Environmental Permit No. EP-364/2009

Air Quality Baseline Monitoring Report

Contract No. HK/2009/04
Wan Chai Development Phase II and
Central – Wan Chai Bypass –
Baseline Sampling, Field Measurement and
Testing Works

Response to Comment - EPD's letter ref.: (26) in EP2/H4/S3/15 Pt.3 dated 25 January 2010

Figure 2.1	Locations of Air Quality Monitoring Stations
------------	--

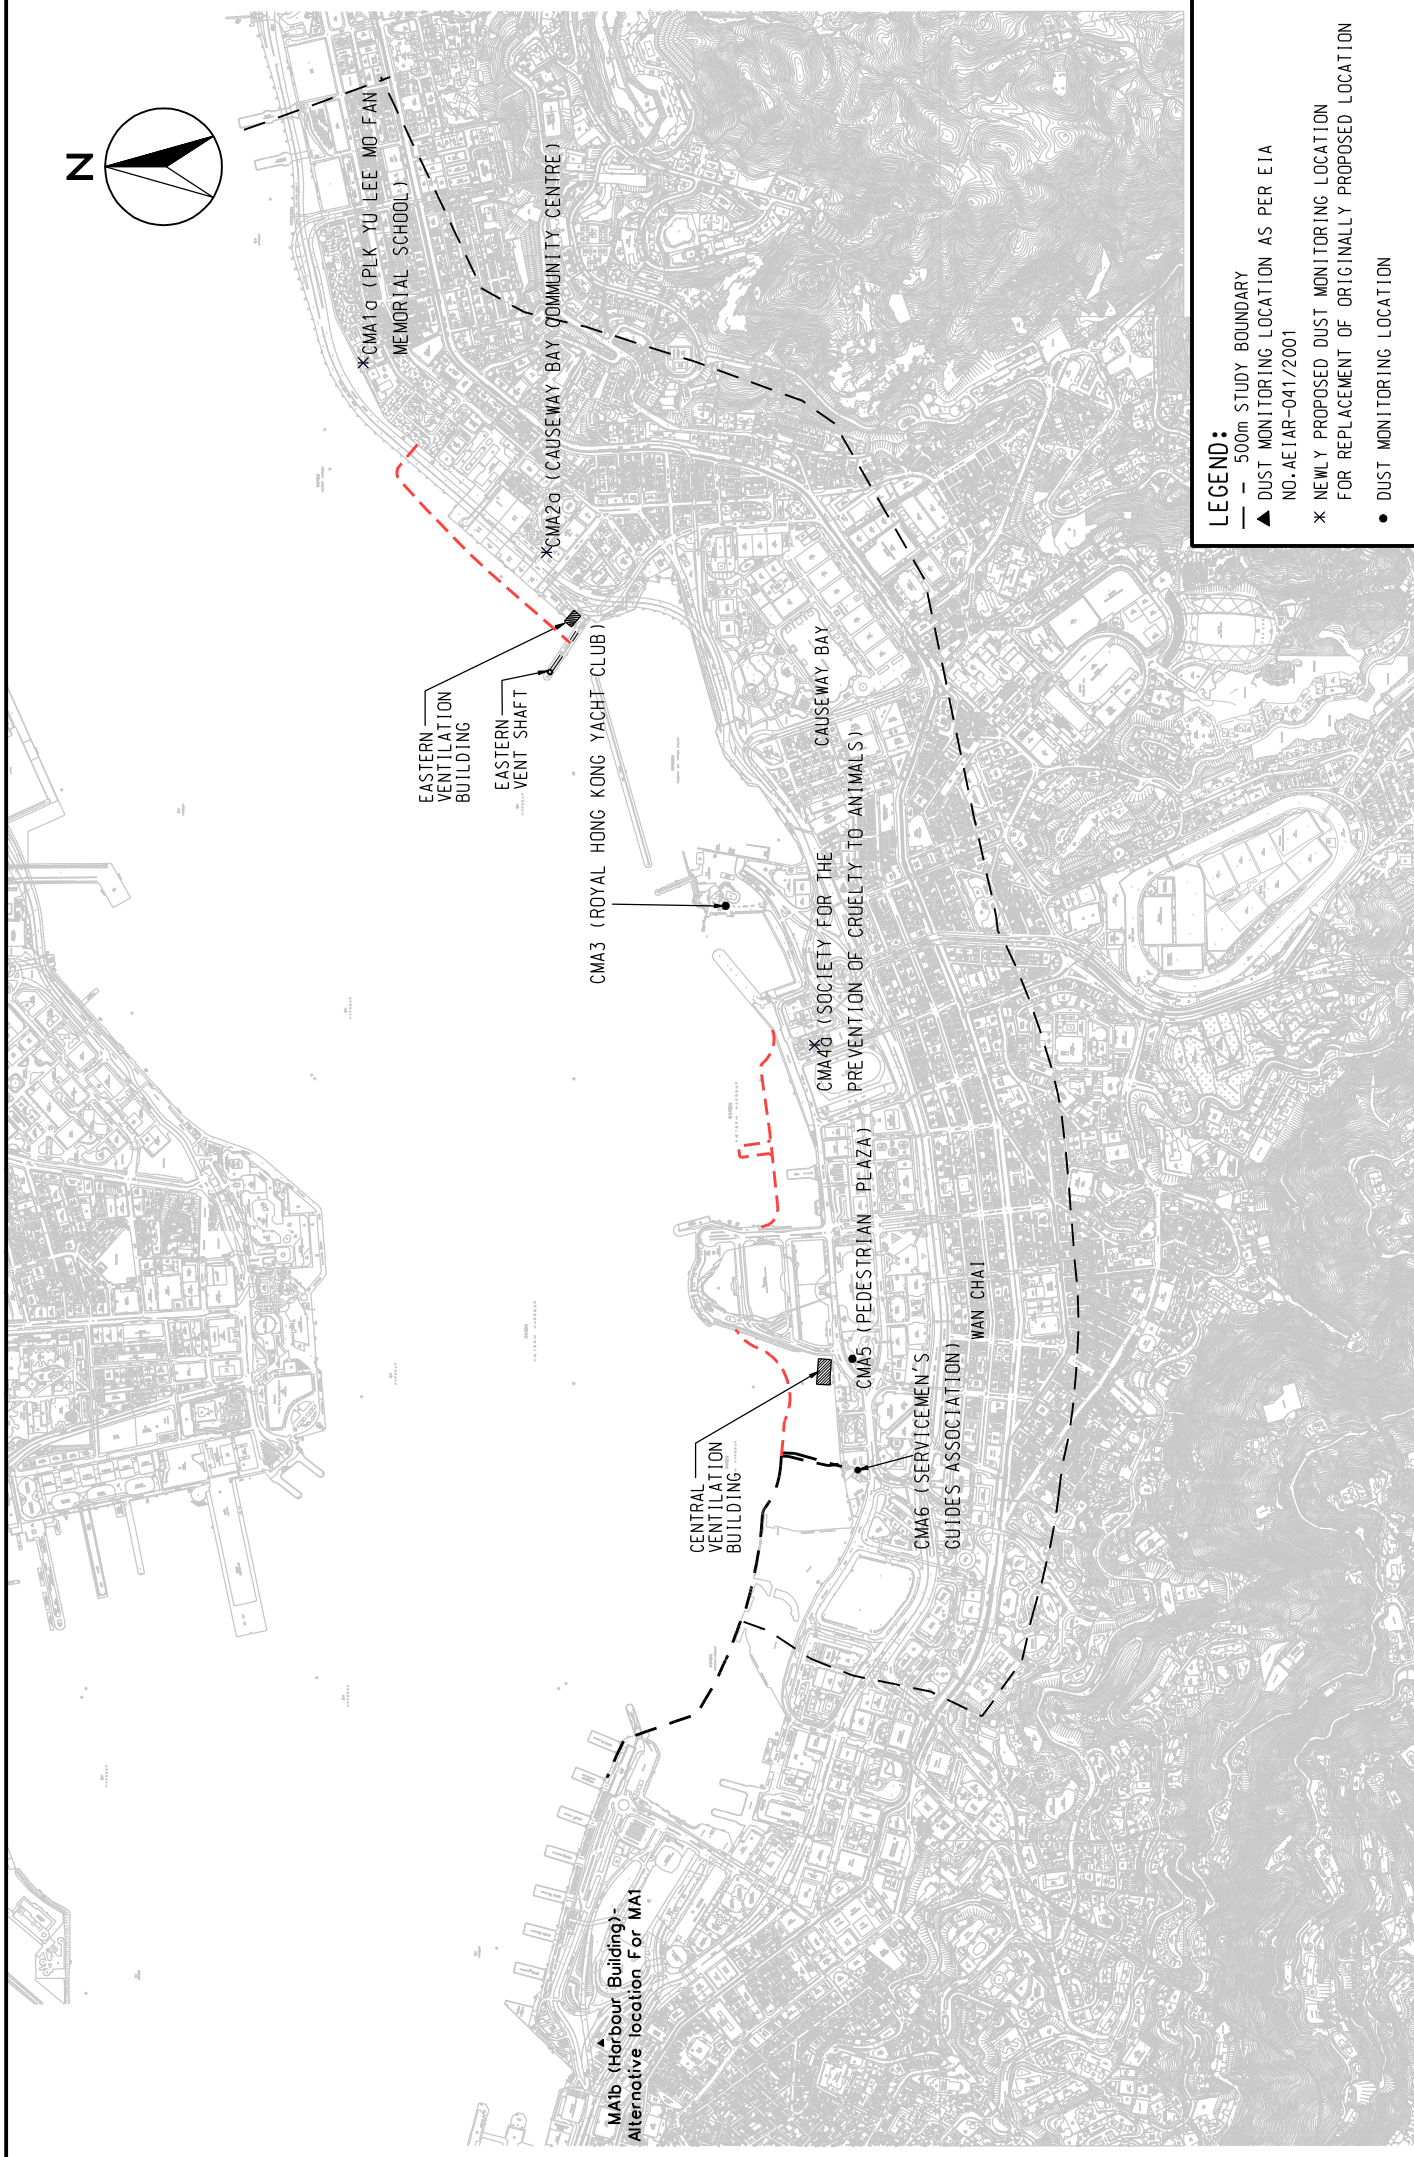
<p>(5) S2.3 – TSP monitoring Locations: Both WDII&CWB EIA report (AEIAR-125/2008) and CWB&IECL EIA report (AEIAR-041/2001) predicted that the worst case construction dust impacts would be at a level of 1.5m above ground. The monitoring samplers should be placed at that level as far as practicable. In particular, a location of roof-top (24-storeys) of a high-rise building (i.e. Station MA1b) is not representative nor acceptable for construction dust monitoring in this project with construction works mainly at ground/low levels. Please explore whether there are alternative locations, e.g. any site office nearby, any low podium or at the site boundary close to the air sensitive receivers. Please provide justifications for the proposed monitoring locations/elevations in the baseline reports.</p>	<p>The monitoring station at Harbour Building (Station MA1b), which is an alternative location for Airport Railway Hong Kong Station (MA1) with similar environmental condition and near the site boundary, is one of the existing air sensitive receivers presented in the EIA Study Report. As the nearby relatively low-rise domestic premises and commercial buildings did not allow us to carry out the baseline air quality monitoring, therefore MA1b was considered to be the most appropriate alternative monitoring location.</p> <p>The monitoring station at roof-top of Harbour Building (Station MA1b) is the only accessible building with the electricity supply for carrying out the consecutive 14-day baseline monitoring. None of the nearby locations at lower level are allowed for such monitoring. Therefore, this location is considered to be the best alternative</p>

location for Airport Railway Hong Kong Station (MA1)								
<u>Proposed alternative monitoring location</u>									
<u>Section 2.3 of Baseline Report:</u>									
<p>(6) It is noted that some alternative air monitoring locations are proposed when compared with the EIA reports. According to S1.4.2, Appendix D2, 'Guidelines for Development project in Hong Kong – Environmental Monitoring and Audit', <i>“When alternative monitoring locations are proposed, the following criteria, as far as practicable, shall be followed:</i></p> <p>(a) <i>at the site boundary or such locations close to the major dust emission source;</i> (b) <i>close to the sensitive receptors; and</i> (c) <i>take into account the prevailing meteorological conditions.”</i></p> <p>Please provide your considerations and justifications for the proposed changes in monitoring locations in the baseline reports</p>

<table><tr> <td>CMA1 - City Garden Block 11 CMA1a - PLK Yu Lee Mo Fan Memorial School (alternative location)</td> </tr><tr> <td><u>Justification:</u> <ul style="list-style-type: none"> CMA1 rejected us to carry out the baseline air monitoring CMA1 and CMA1a were both located at the site boundary with similar environmental condition The roof-top height of CMA1a (4 floor) was lower than CMA1 (27 floor) </td> </tr><tr> <td>CMA2 - Victoria Centre CMA2a - Causeway Bay Community Centre (alternative location)</td> </tr><tr> <td><u>Justification:</u> <ul style="list-style-type: none"> CMA2 rejected us to carry out the baseline air monitoring CMA2 and CMA2a were both located at the site boundary with similar environmental condition The roof-top height of CMA2a (4 floor) was lower than CMA2 (30 floor) </td> </tr><tr> <td>CMA4 - Wanchai Sports Ground CMA4a - Society for the Prevention of Cruelty to Animals (alternative location)</td> </tr><tr> <td><u>Justification:</u> <ul style="list-style-type: none"> CMA4 rejected us to carry out the baseline air monitoring CMA4a was also one of air sensitive receivers in EIA Study Report CMA4 and CMA4a were both located at the site boundary with similar environmental condition </td> </tr><tr> <td>MA1 - Airport Railway Hong Kong Station MA1b - Harbour Building (alternative location)</td> </tr><tr> <td><u>Justification:</u> <ul style="list-style-type: none"> Refer to response to comment item (5) </td> </tr></table>
